CARROLL COUNTY BOARD OF COMMISSIONERS 211 MOODY AVE SW OFFICE RENOVATION

HAI PROJECT NO. 24013.000

TO: ALL BIDDERS

This Addendum becomes a part of the Contract Documents and modifies the original Bidding Documents dated October 15, 2024, as noted below. The Bidder shall acknowledge receipt of this Addendum on the Form of Proposal. Failure to do so may subject the Bidder to disqualification.

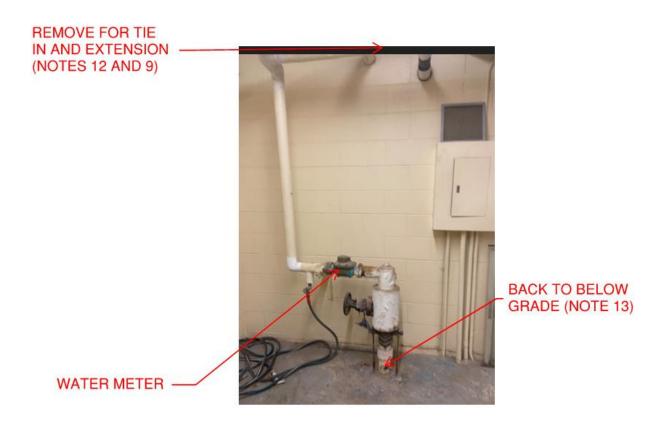
30. **Question:** P-102 note 12 talks about removing the waterline back to this point. p-102 note 13 talks about removing water main and caping main in the underground. P-202 note 9 talks about tying water line back into the water service? Can you please provide some direction?

Answer: Note remains as is. Remove piping back and extend new piping under new work. Upstream piping from service being removed is addressed by note 13. Piping from service needs removed back to below grade as noted in note 13. Downstream piping needs removed back to point indicated by note 12. This service is anticipated to be abandoned and is currently backfed from the newer water service located in the basement boiler room. Work to be closely coordinated with water dept. Refer to section view below.

GENERAL INFO & TYPICAL MILLWORK **DETAILS**

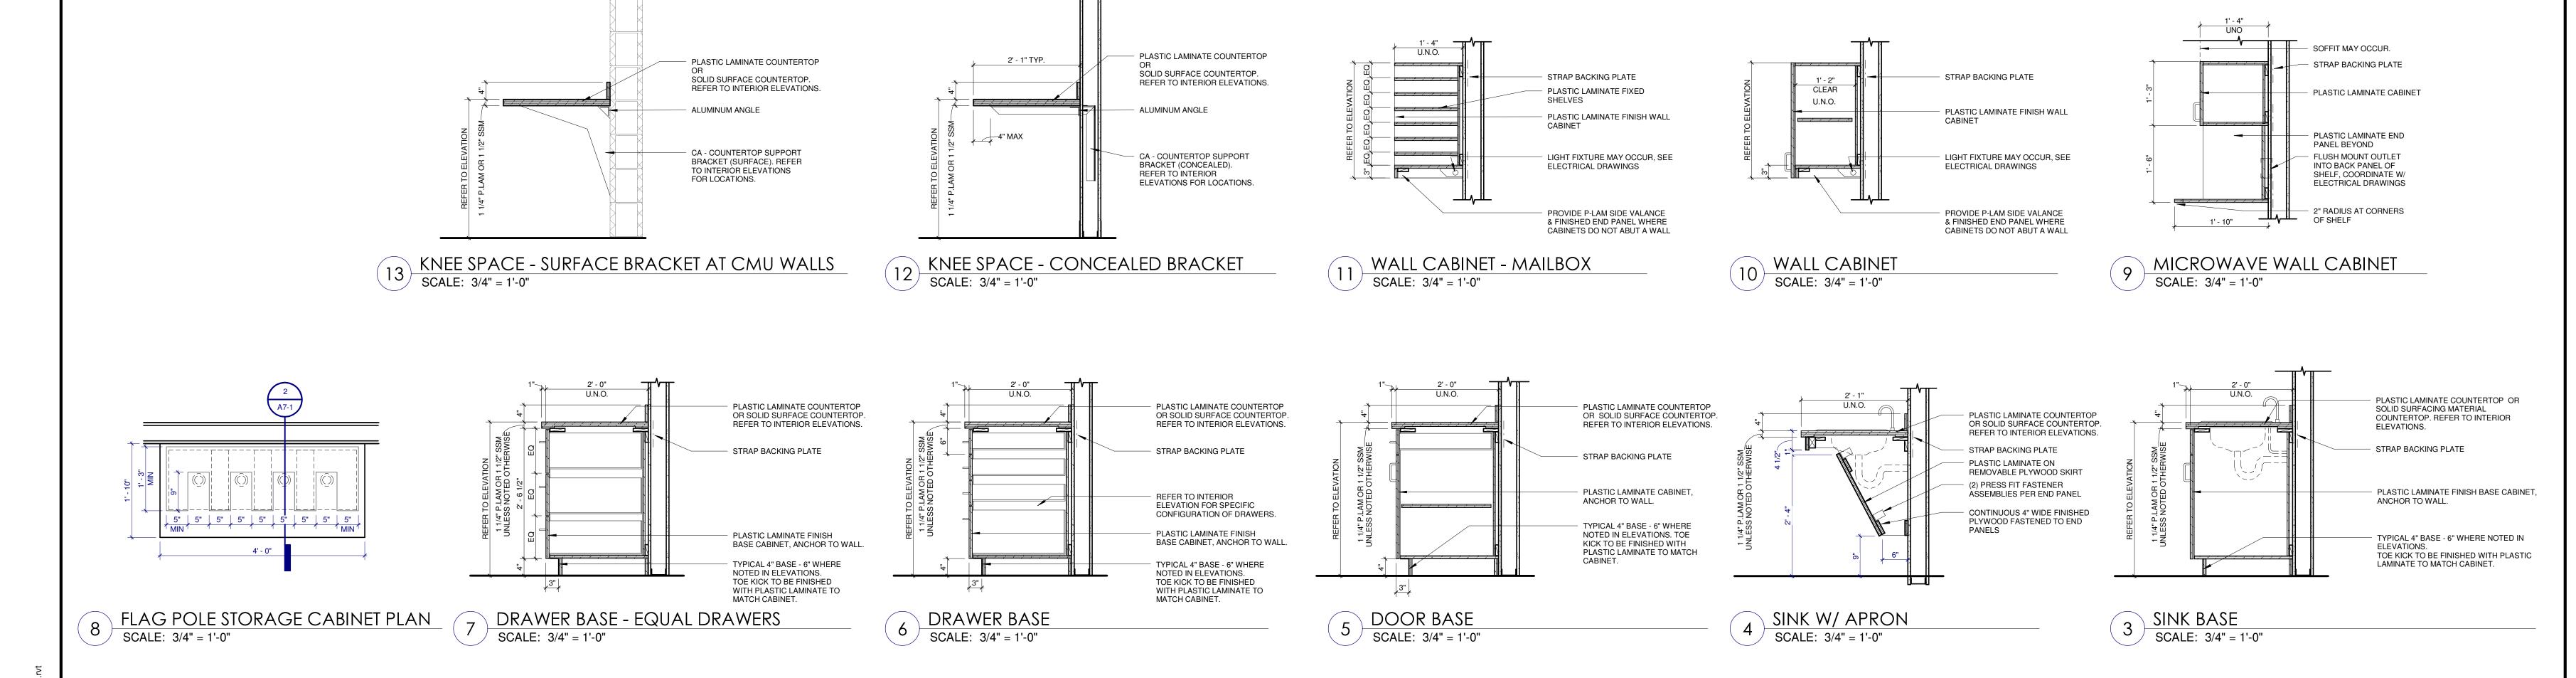
39. **Question:** According to page A7-1 under the detail for "typical millwork elevations" it shows a keycode lock indication. Spec section 064023.7 line "j" Calls for national lock NO. C-8053 please provide information on the intent or design of the lock to be used. The keycode lock does not have a specification. Please advise.

Answer: The keycode lock should be removed from the project as it is not used. A7-1 updated to reflect this.

INTERIOR ELEVATIONS

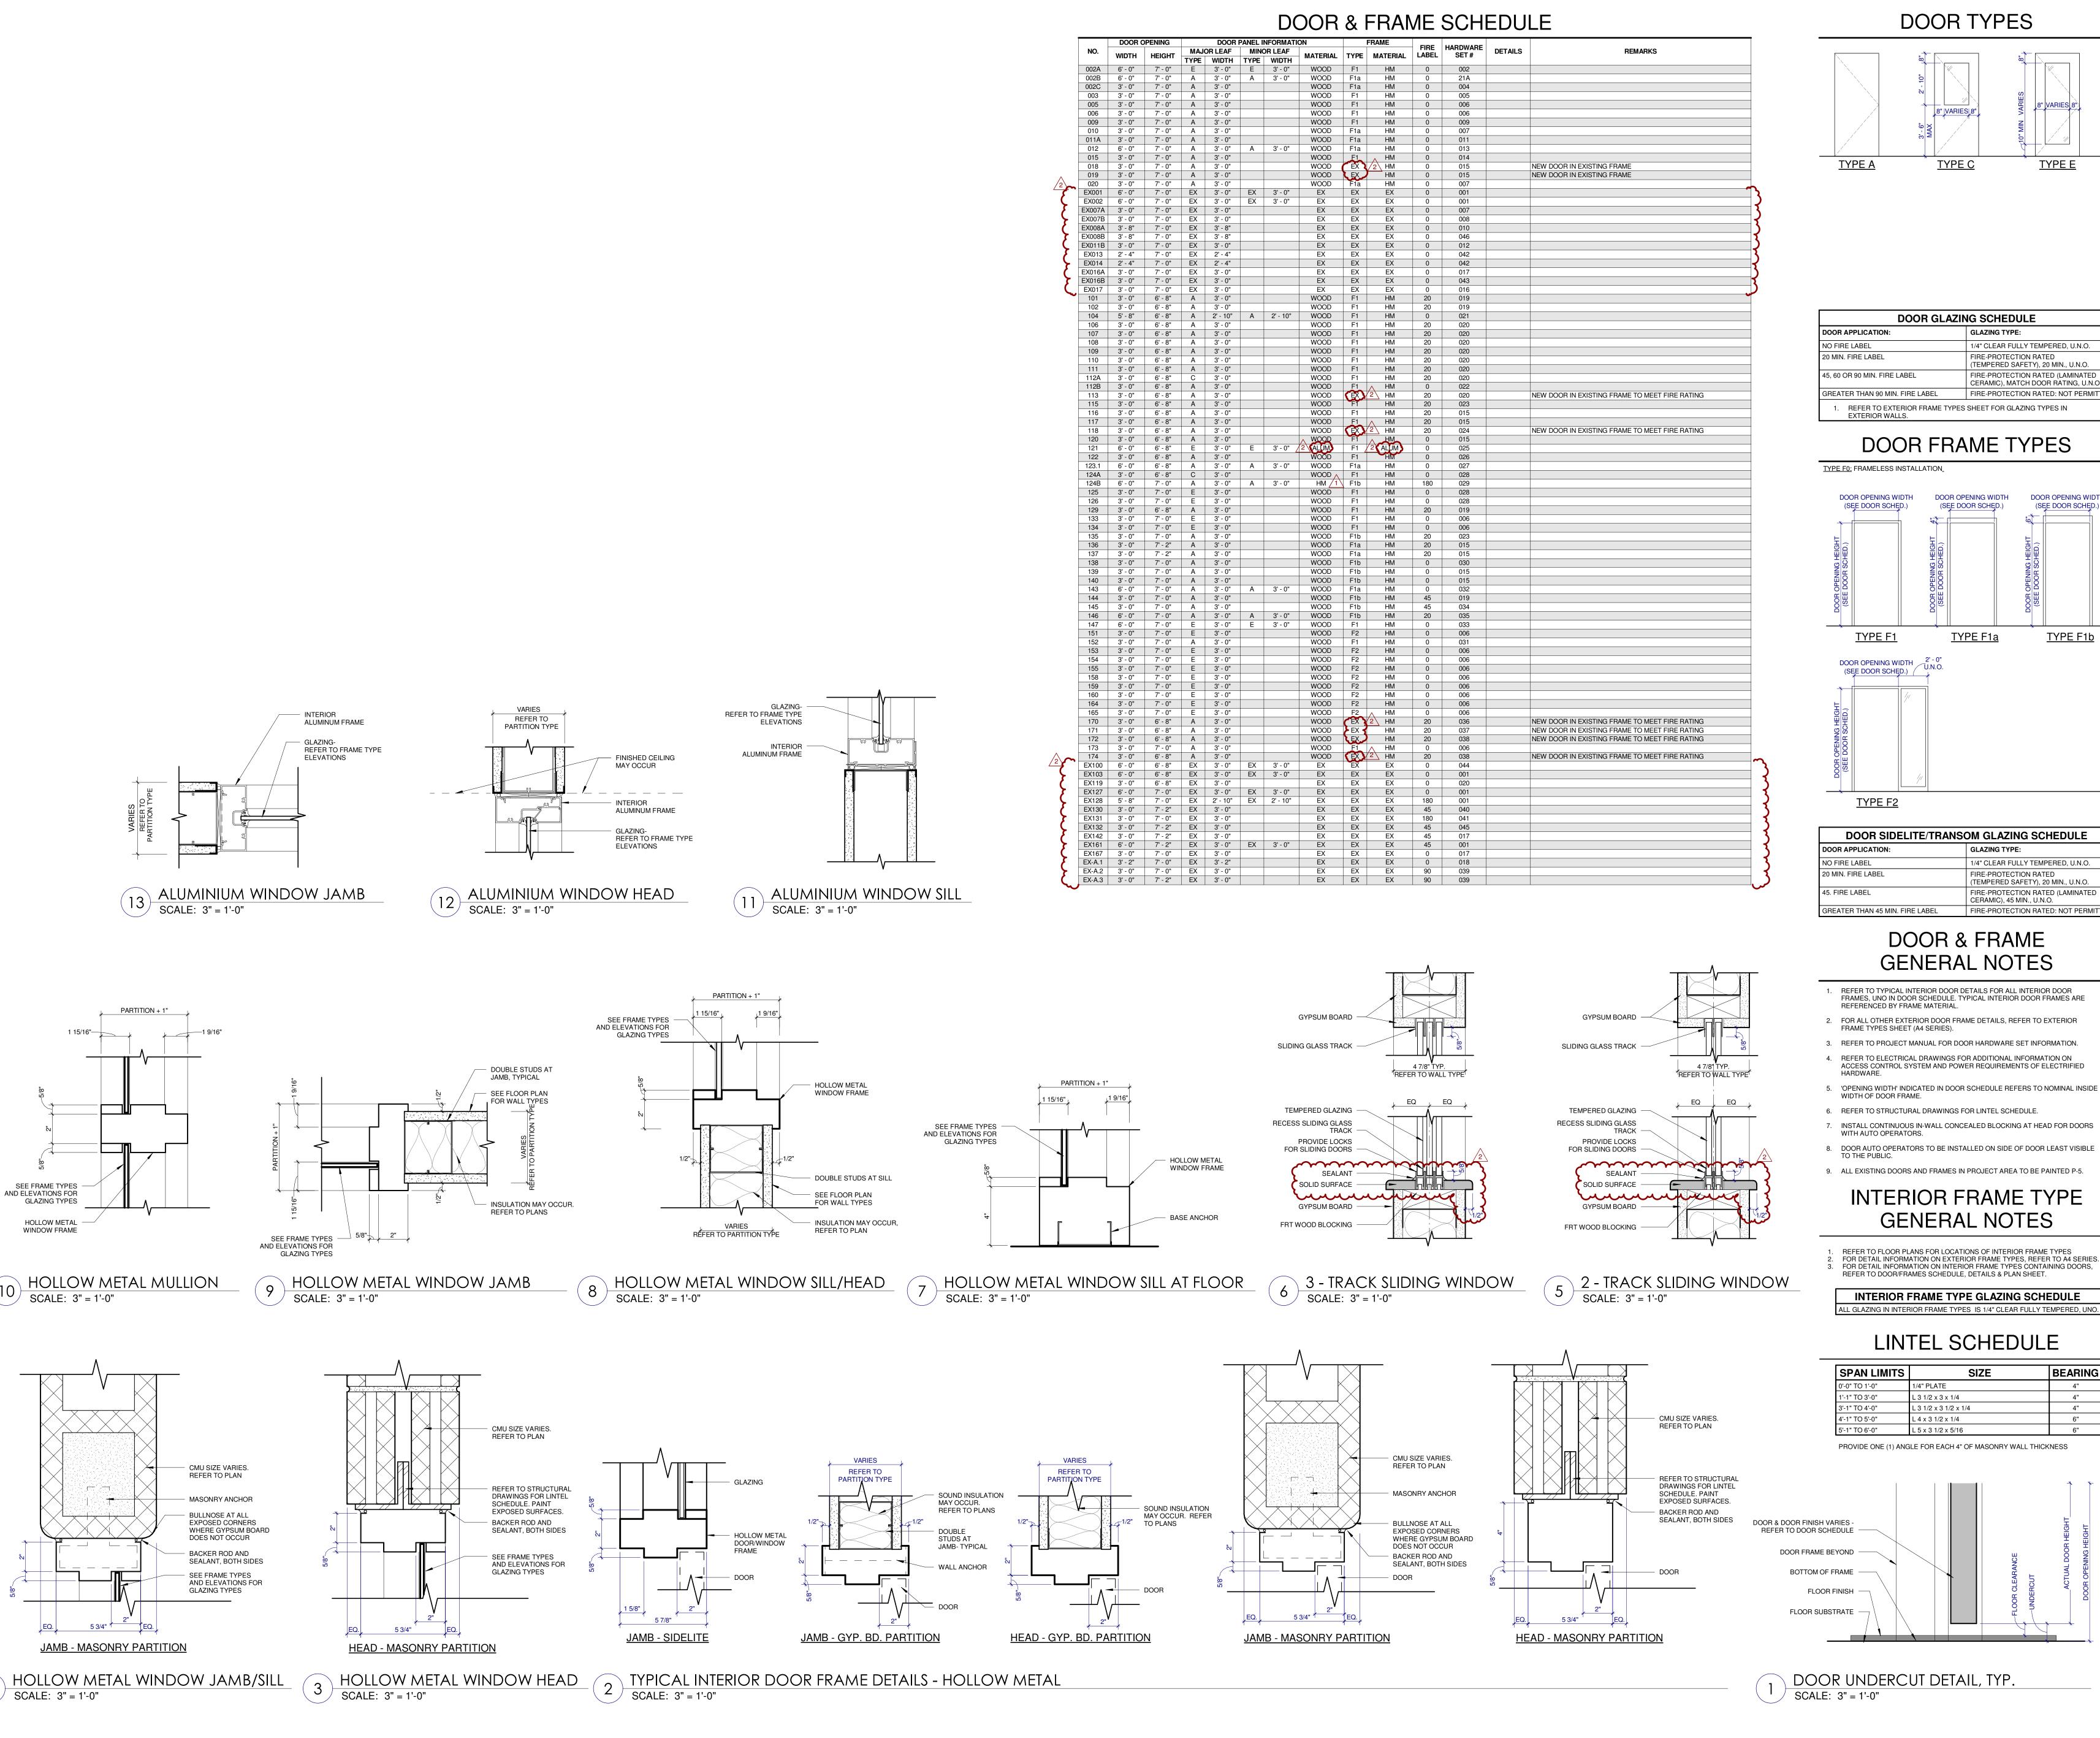
- 12. Question: Specifications include 113100 Residential Appliances which include MO-1, RF-1, DW-1, etc. Per drawing elevation sheets A7-1 to A7-5 it shows these appliances dashed which says "Owner Furnished, Owner Installed". Please clarify if appliances are by contractor or owner. Answer: Updated A7-2 and A7-4 to reflect appliances being furnished and installed by Contractor.

DOOR & FRAME **SCHEDULES & DETAILS**

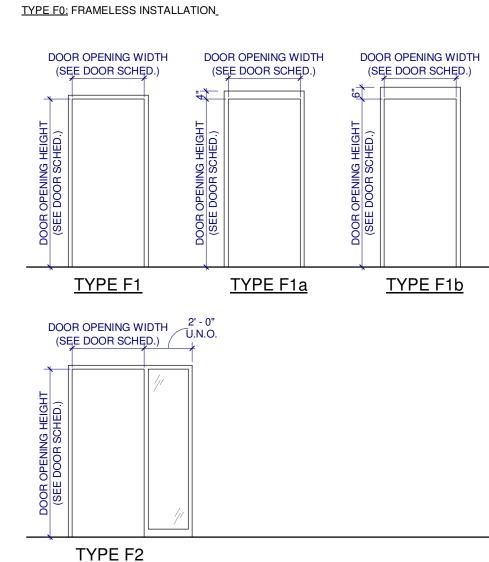
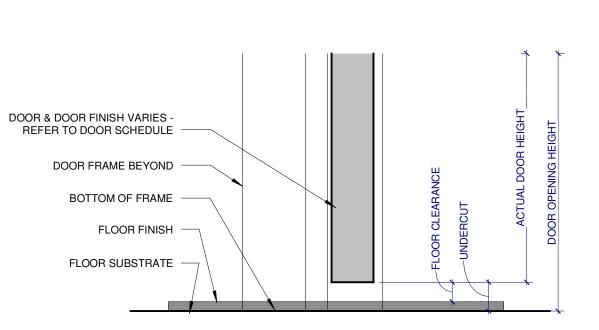
- 7. **Question:** Opening #121 is a pair of doors detailed as door type E, wood door x HMF. The hardware set detailed is hardware set #025 which makes reference to door seal & meeting stile furnished by aluminum door supplier. Is this opening supposed to be an aluminum door & frame or a wood door and hollow metal frame as detailed?

- **Answer:** Opening revised to be aluminum door and frame.
